SERVICE BULLETIN	
PRODUCT:	DLP PROJECTION TV
BULLETIN NUMBER:	ASC20040923001
BULLETIN DATE:	09/23/2004
MODELS:	HLP4663W, HLP5063W, HLP5663W, HLP6163W
Chassis	L62B Atlantis Chassis

SUBJECT: The unit will not power on.

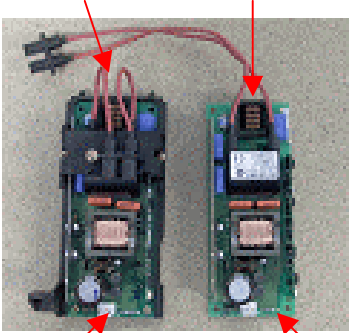
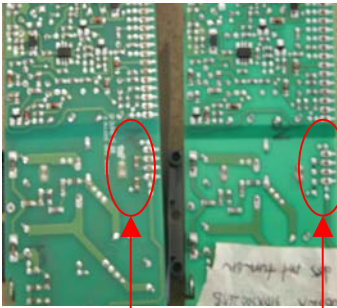
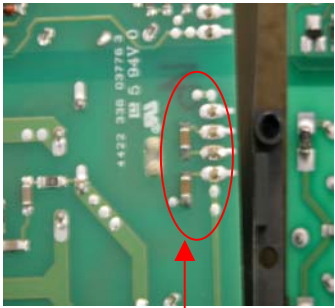
REPAIR: There has been a problem found with the ballast assembly in the models listed above. There were 2 modifications made to the ballast to improve reliability. The modifications include the addition of two capacitors to the Ballast board and the shortening of the ballast cables from 230mm to 130mm. Please refer to the photos below for modifications and location.

130mm
wire

230 mm
wire

MODIFICATION
These two capacitors
were added

PROCEDURE: Replace the Ballast PCB if the unit you are servicing falls within the serial number ranges listed for this problem. Order part number BP96-00690A.
